PSLTR-00-0057

Dresden Nuclear Power Station, Units 2 and 3
Facility Operating License Nos. DPR-19 and DPR-25
NRC Docket Nos. 50-237 and 50-249

Subject: Request for an Amendment to Technical Specifications Section 3 /4.6.K, "Primary System Boundary" and Section 3 /4.12.C "Special Test Exceptions" and Request for Exemption from 10CFR 50.60, "Acceptance criteria for fracture prevention measures for lightwater nuclear power reactors for normal operation."

FIGURE 3.6.K-3

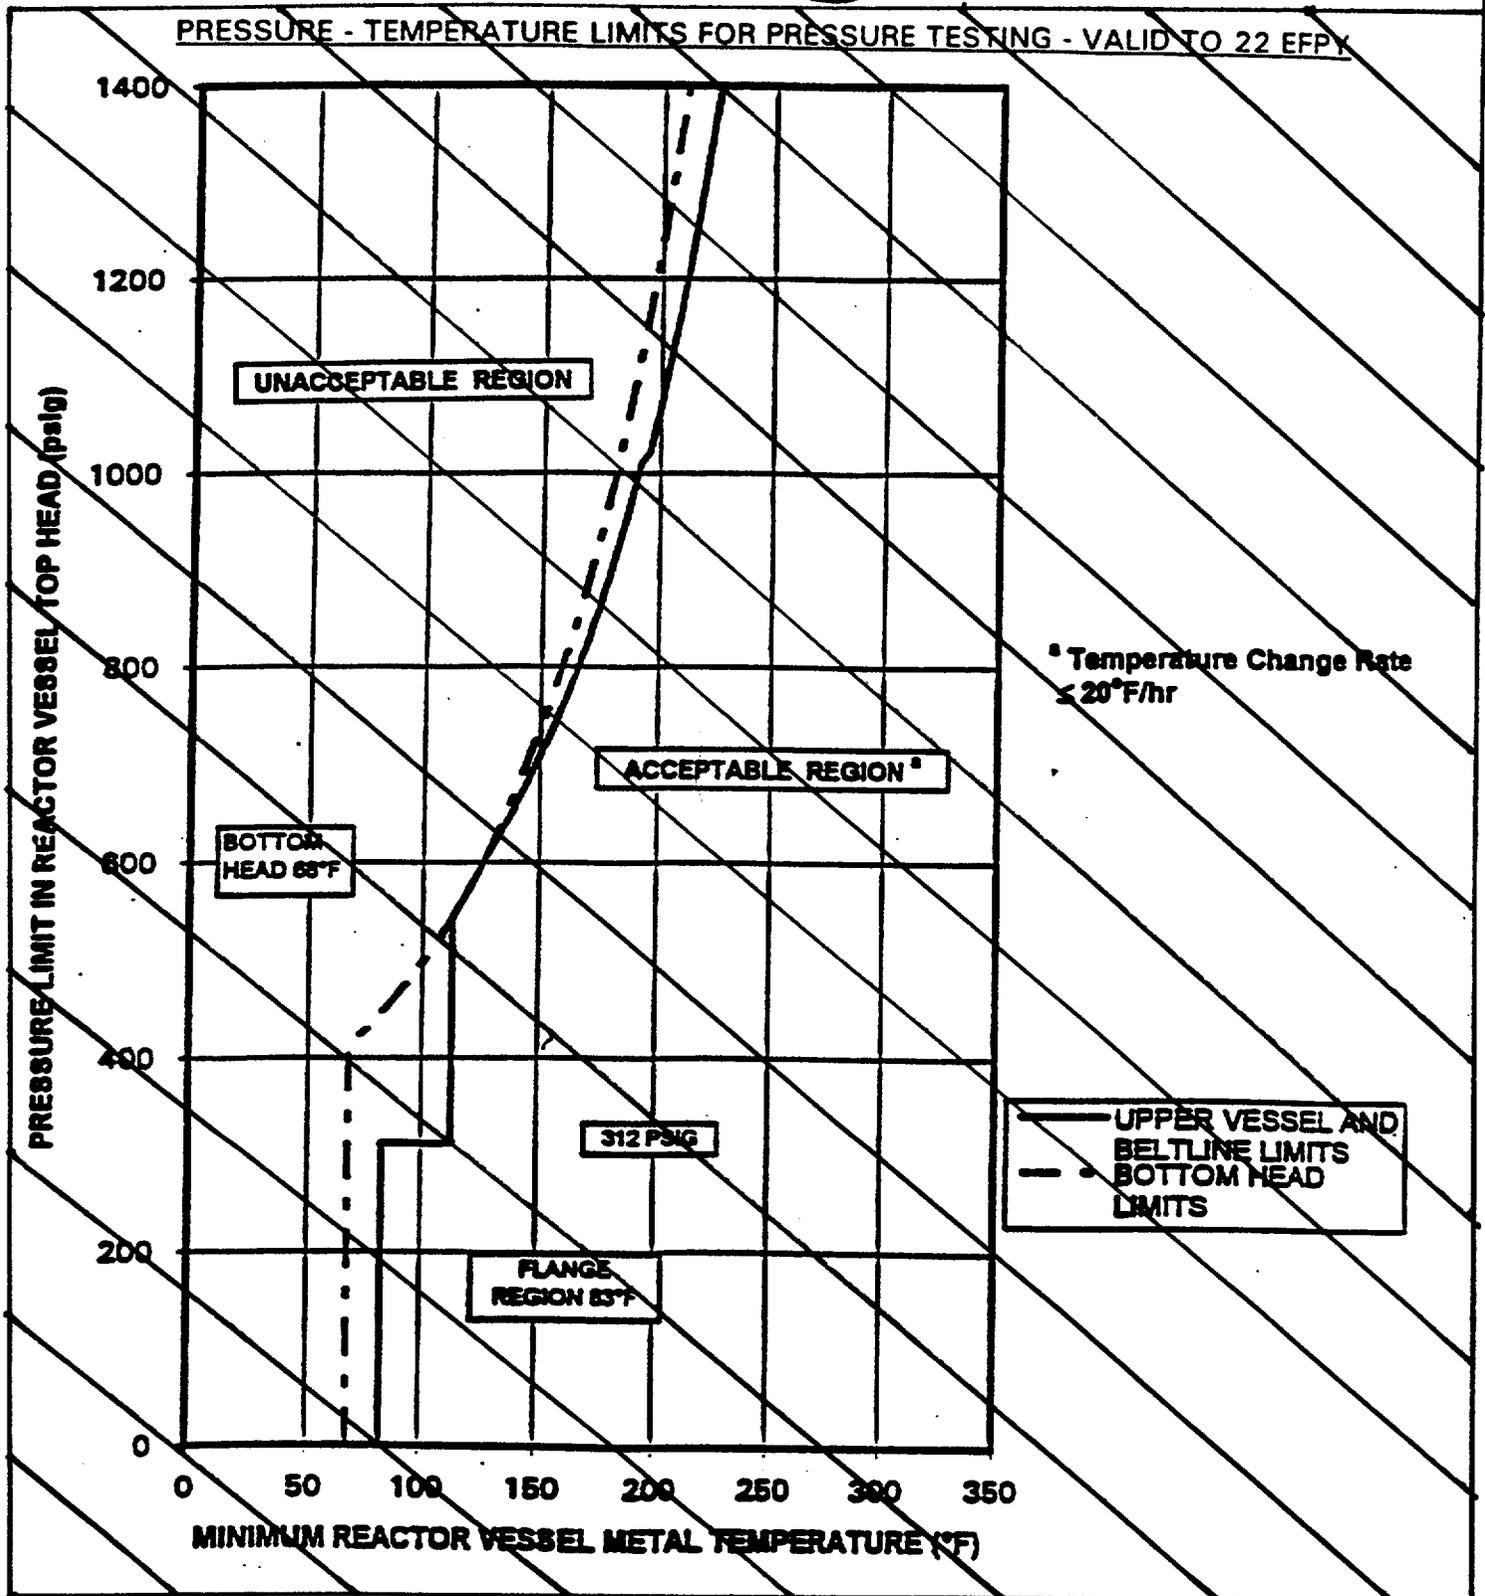
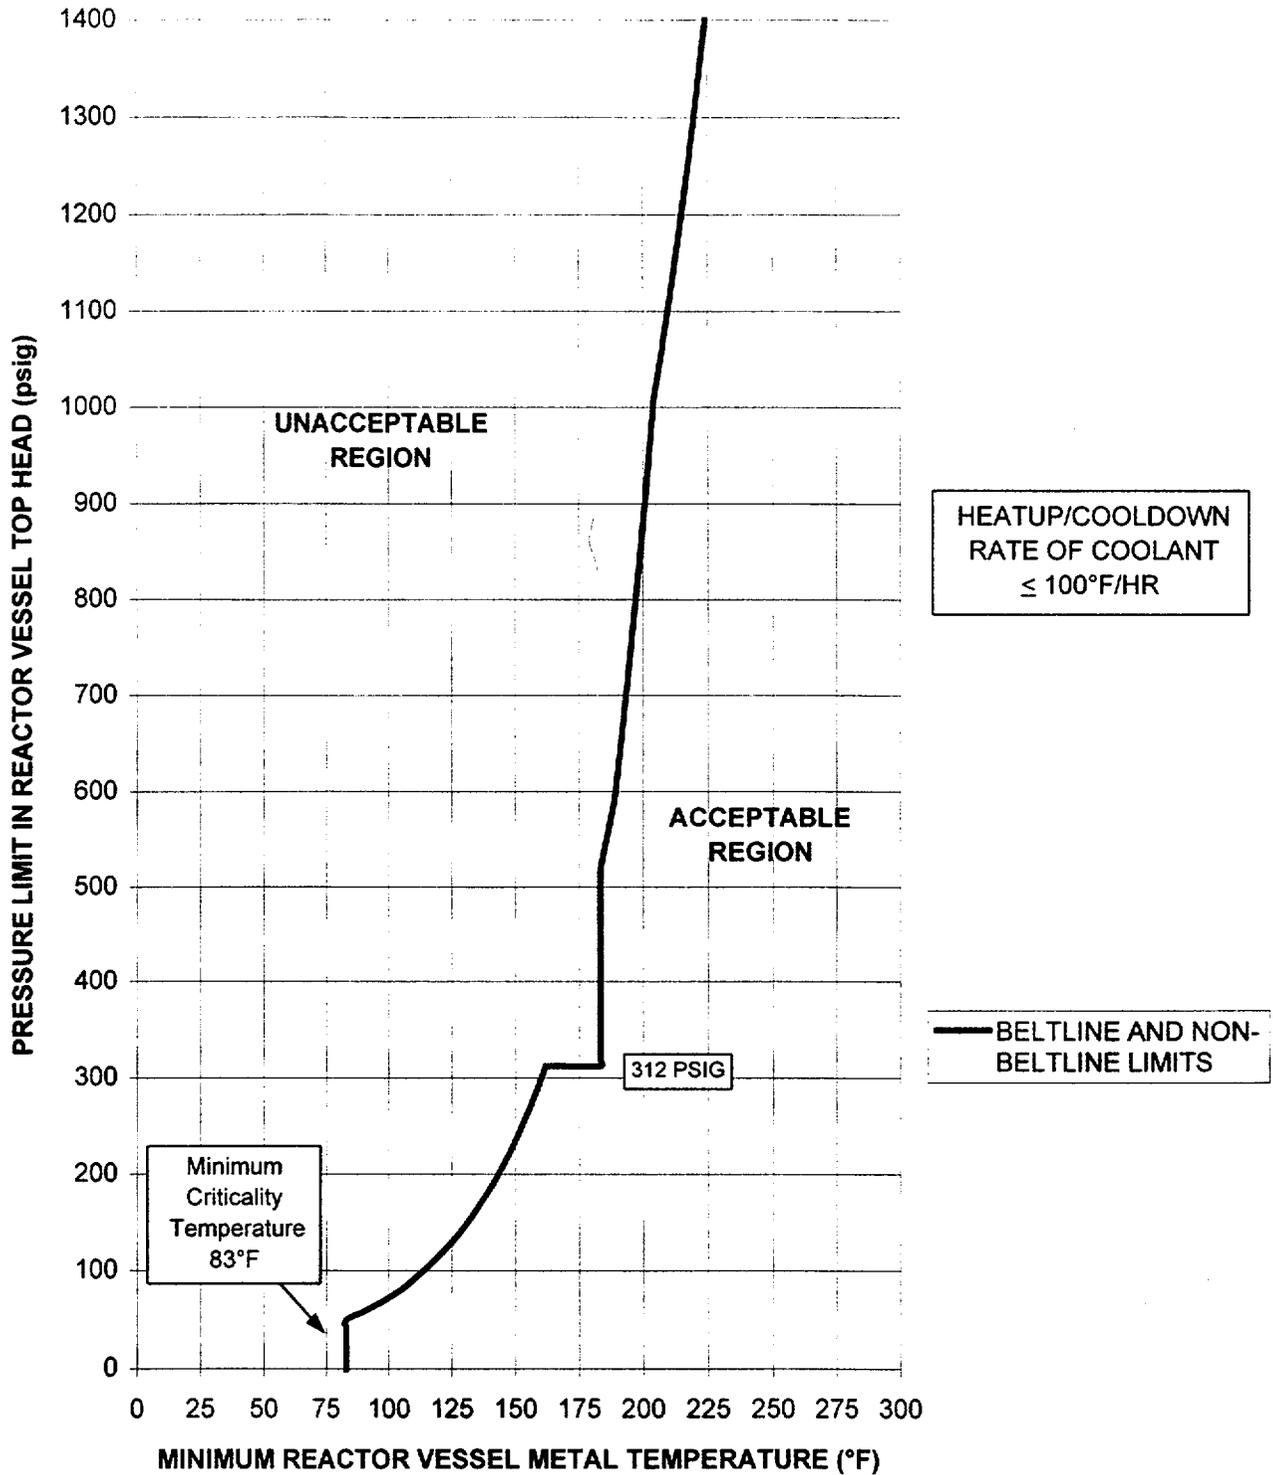
The proposed changes revise TS Figures 3.6.K-1 through 3.6.K-5, and delete the Special Test Exception for Inservice Leak and Hydrostatic testing operation. The proposed TS Figures 3.6.K-1 through 3.6.K-3 are bounding P-T curves for Unit 2 and Unit 3 RPVs.

b. The reactor vessel metal temperature and pressure to be within the Acceptable Region on Figure 3.6.K-3.

3. Nuclear Heatup and Cooldown:
 - a. The reactor vessel metal temperature and pressure shall be maintained within the Acceptable Region as shown on Figure 3.6.K-~~6~~³, and
 - b. The rate of change of the primary system coolant temperature shall be $\leq 100^{\circ}\text{F}$ per hour.
4. The reactor vessel flange and head flange temperature $\geq 83^{\circ}\text{F}$ when reactor vessel head bolting studs are under tension.

PRESSURE - TEMPERATURE LIMITS FOR CRITICAL CORE OPERATIONS - VALID TO 32 EFY

FIGURE 3.6.K-4

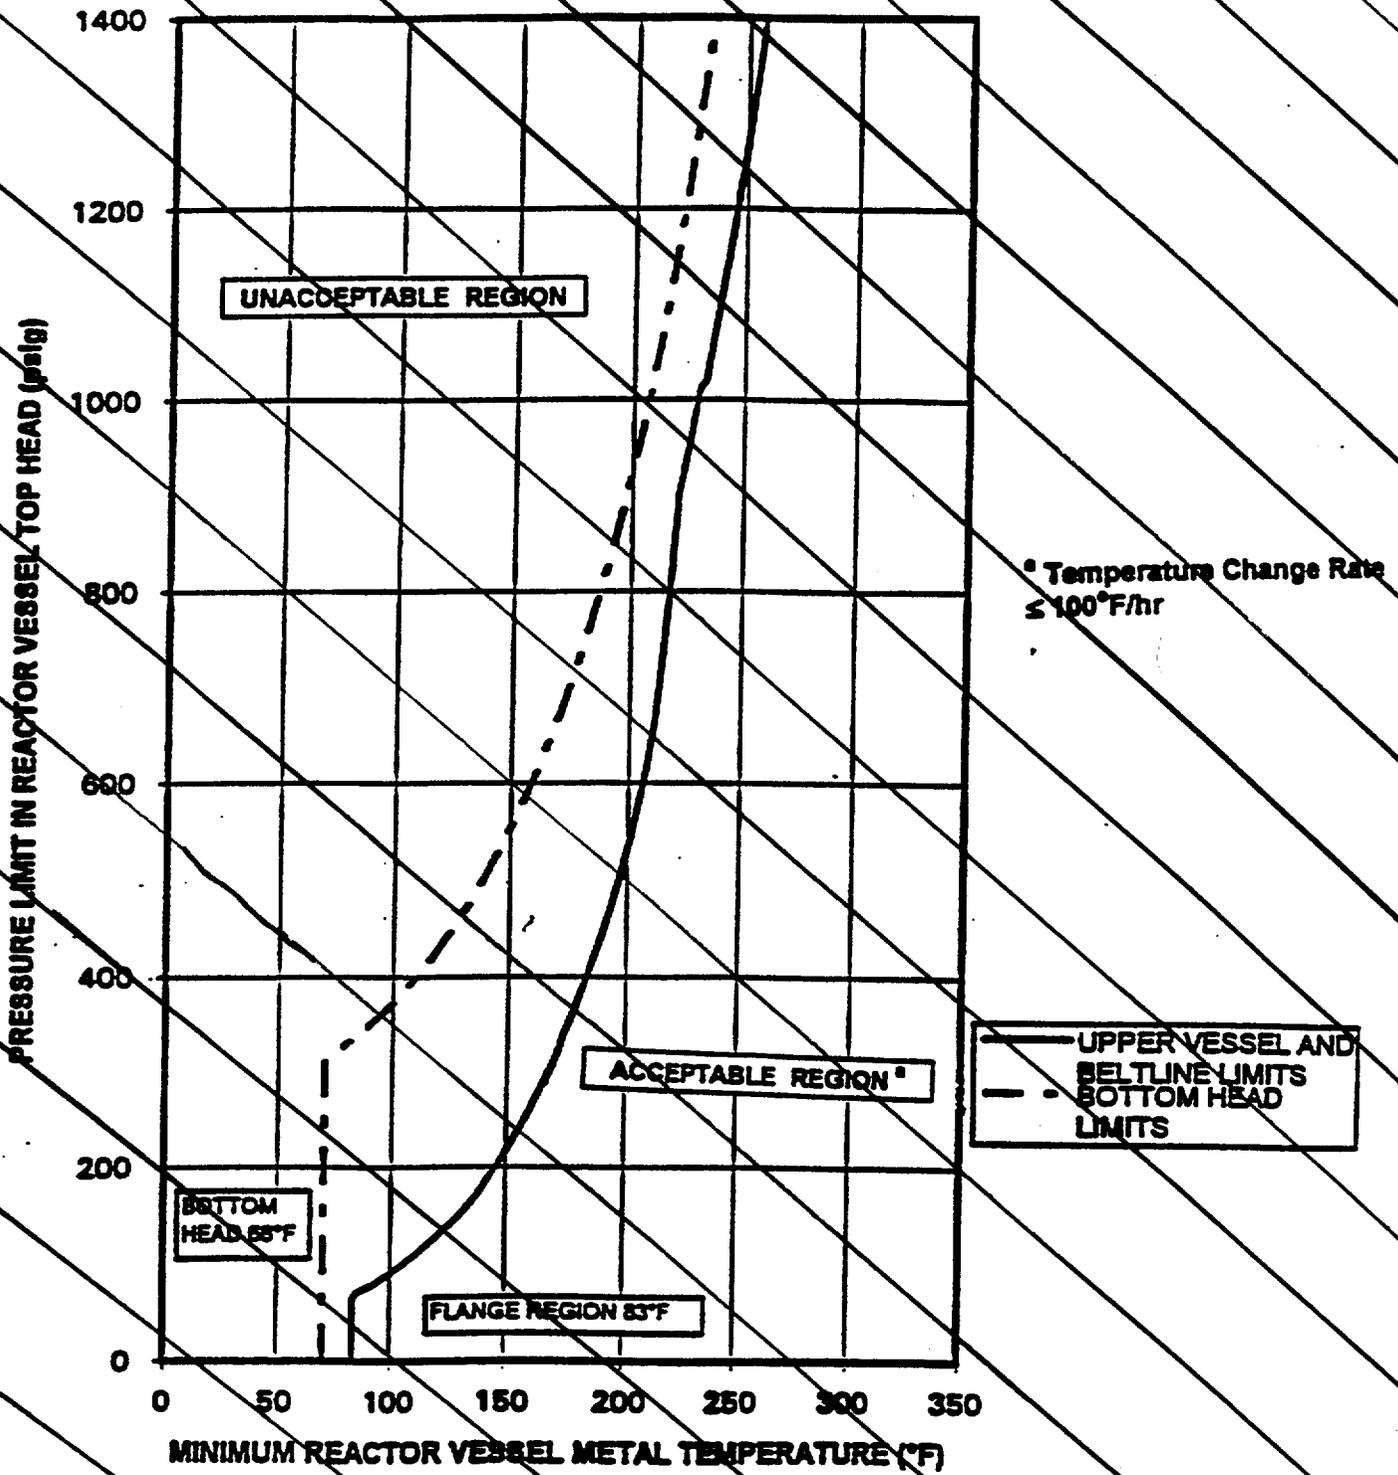
The pressure-temperature limit lines are shown, for operating conditions; Pressure Testing, Figure 3.6.K-1 ~~(through 3.6.K-3)~~, Non-Nuclear Heatup/Cooldown, Figure 3.6.K-4, and Core Critical Operation Figure 3.6.K-5. The curves have been established to be in conformance with Appendix G to 10 CFR Part 50 and Regulatory Guide 1.99 Revision 2, and take into account the change in reference nil-ductility transition temperature (RT_{NDT}) as a result of neutron embrittlement. The adjusted reference temperature (ART) of the limiting vessel material is used to account for irradiation effects.

Figure 3.6.K-4 applies during heatups with non-nuclear heat (e.g., recirculation pump heat) and during cooldowns when the reactor is not critical (e.g., following a scram). The curve provides the minimum reactor vessel metal temperatures based on the most limiting vessel stress. The maximum heatup/cool-down rate of 100°F/hour is applicable.

FIGURE 3.6.K-5

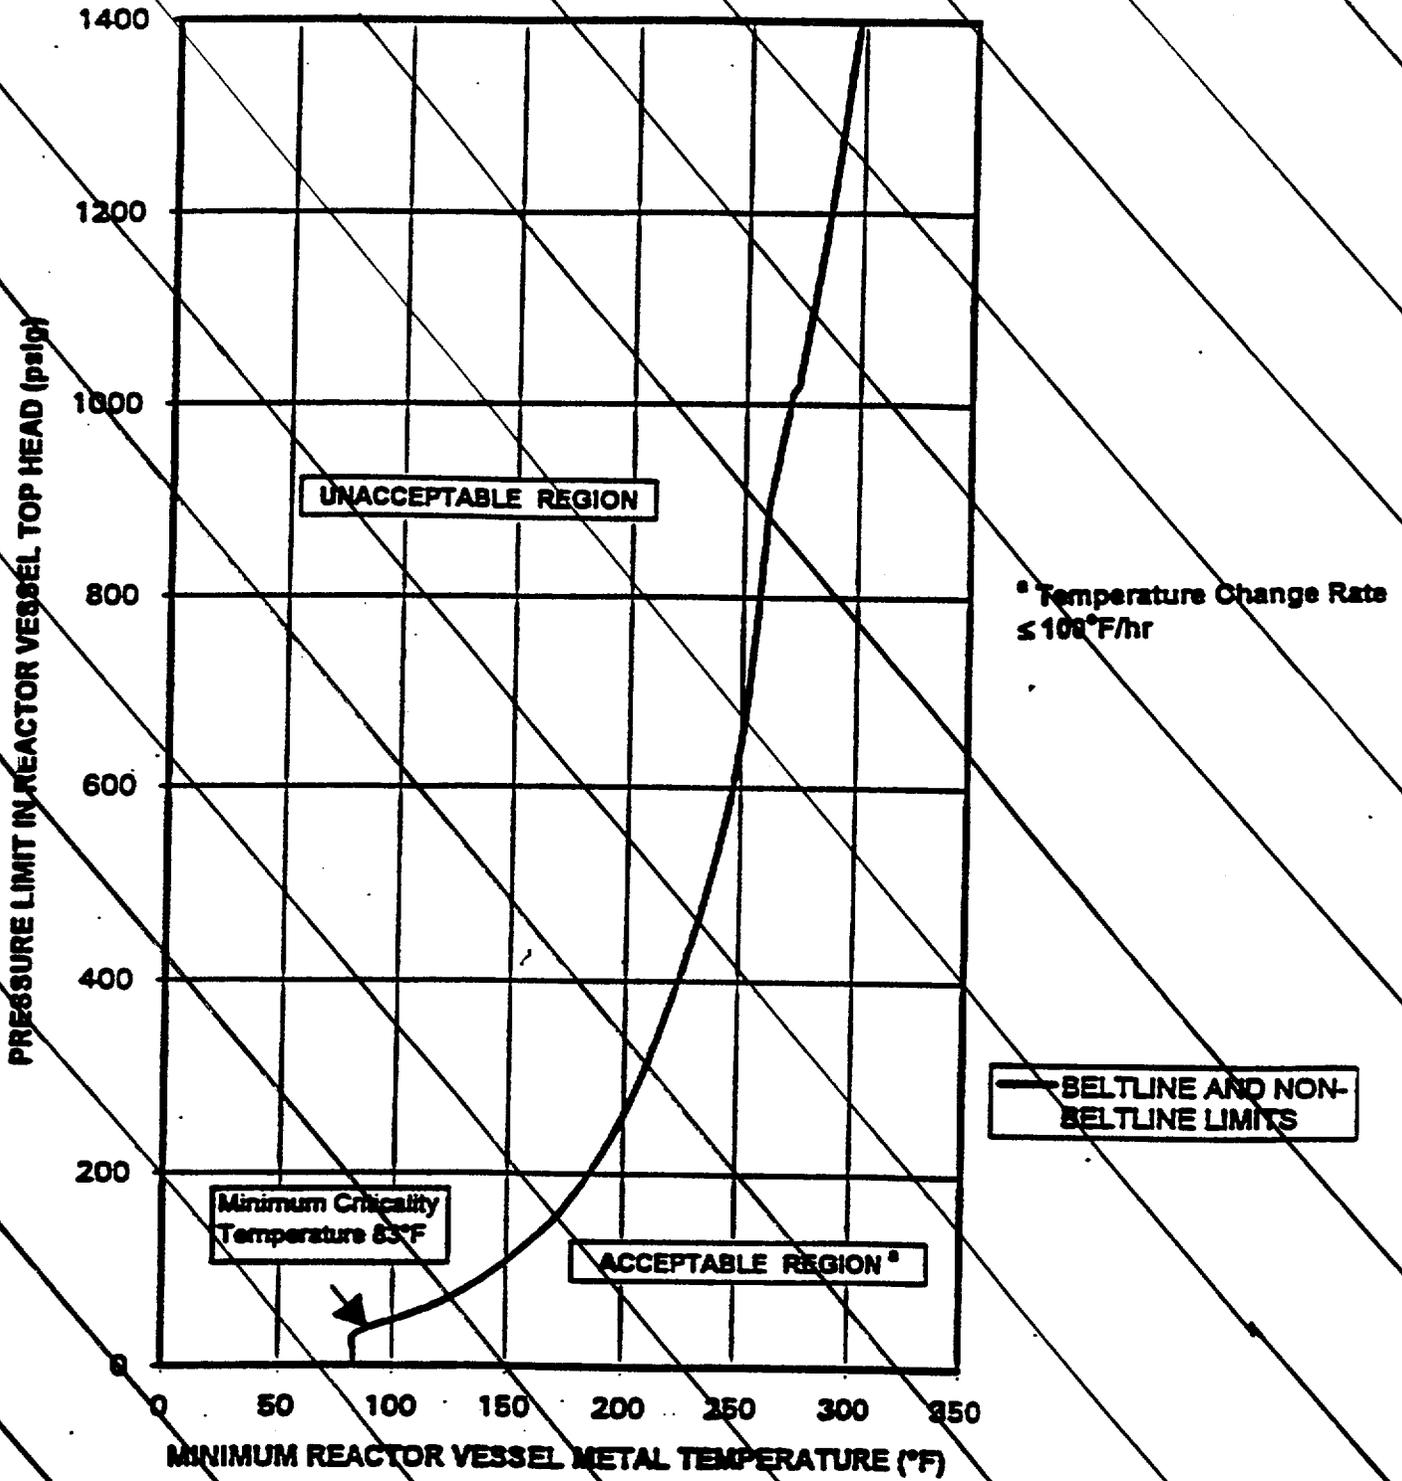
The core critical operation curve shown in Figure 3.6.K-5, is generated in accordance with 10CFR Part 50 Appendix G which requires core critical pressure-temperature limits to be 40°F above any pressure testing or non-nuclear heatup/cool-down limits. Since Figure 3.6.K-4 is more limiting, Figure 3.6.K-5 is Figure 3.6.K-4 plus 40°F. The maximum heatup/cool-down rate of 100°F/hour is applicable.
